TEXAS COMMISSION ON ENVIRONMENTAL QUALITY

Re: Approval to Conduct On-Site Wastewater Treatment and Irrigation
Falcon Refinery
1472 FM 2725, San Patricio County, Ingleside, Texas 78362
SUP111

INTEROFFICE MEMORANDUM

Subject: National Oil Recovery Corporation (NORCO), Falcon Refinery Superfund Site (the facility)

WATER TREATMENT AND IRRIGATION SYSTEM

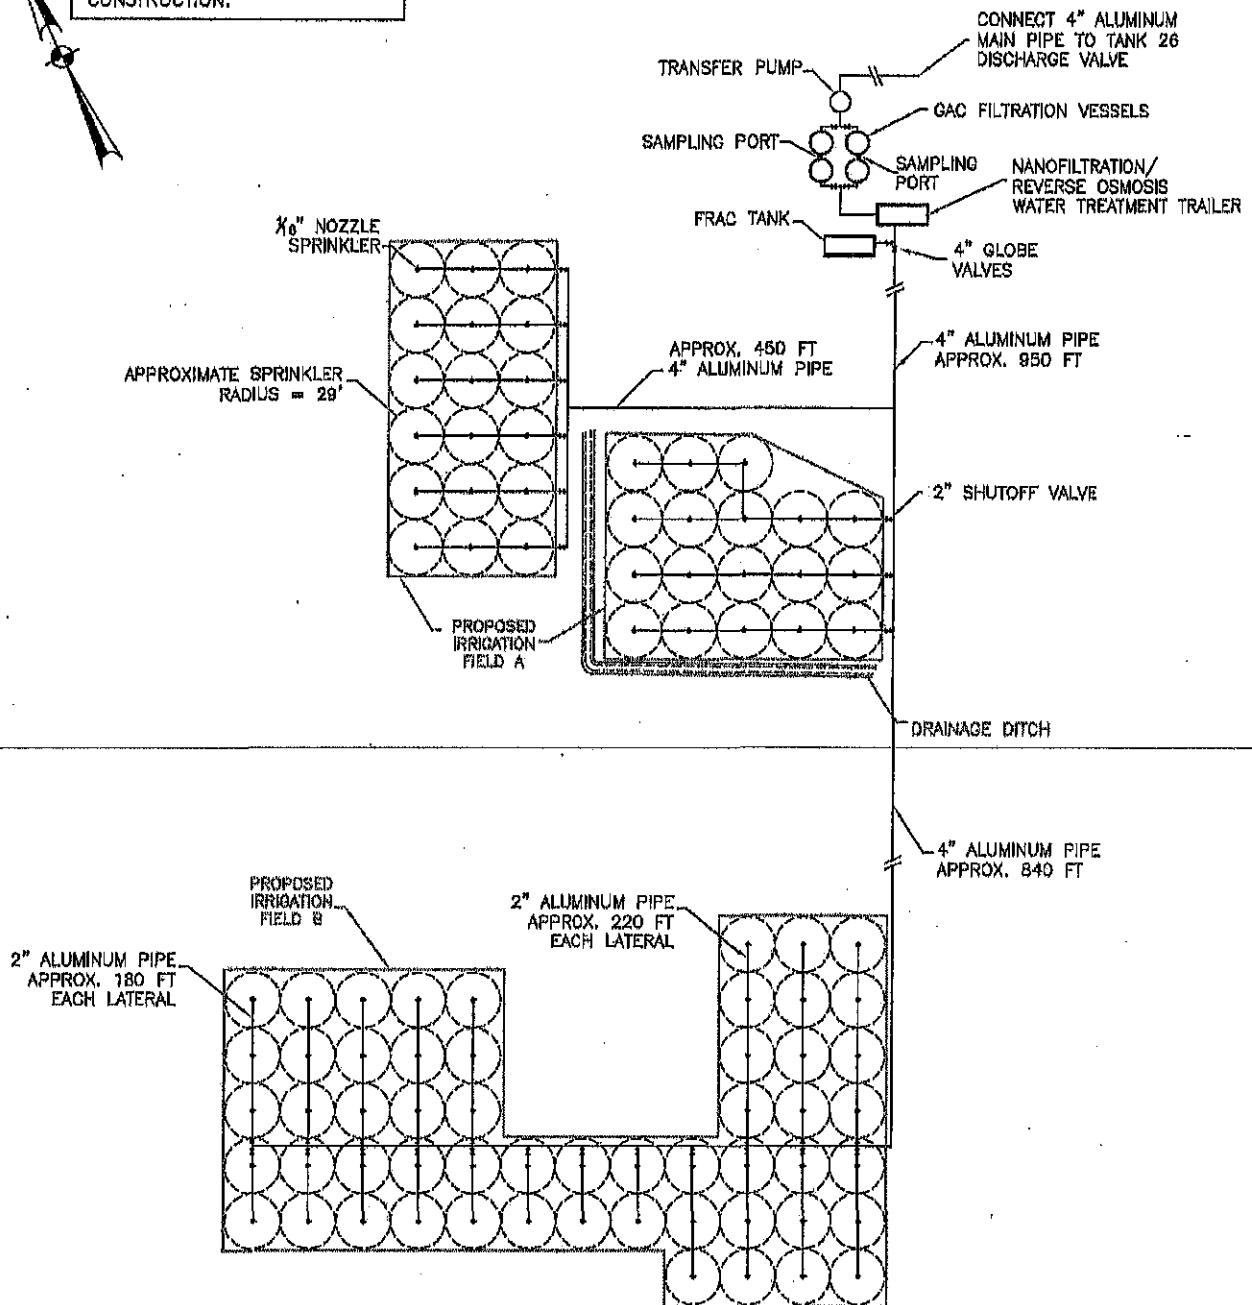
7. The irrigation system shall be constructed in accordance with the conceptual design provided in Attachment C.
8. The quality and the loadings of the treated wastewater shall be maintained as follows:
 - a. hydraulic loading: ≤ 3.18 inches per acre per month (in/ac/month)
 - b. daily maximum effluent flow: $\leq 15,649$ gallons per day (0.015649 MGD)
 - c. daily maximum total nitrogen loading: ≤ 0.436 lbs/acre/day
 - d. conductivity: < 4.0 milli-Siemens per centimeter (mS/cm)
 - e. pH: between 6.0 and 9.0 standard units.
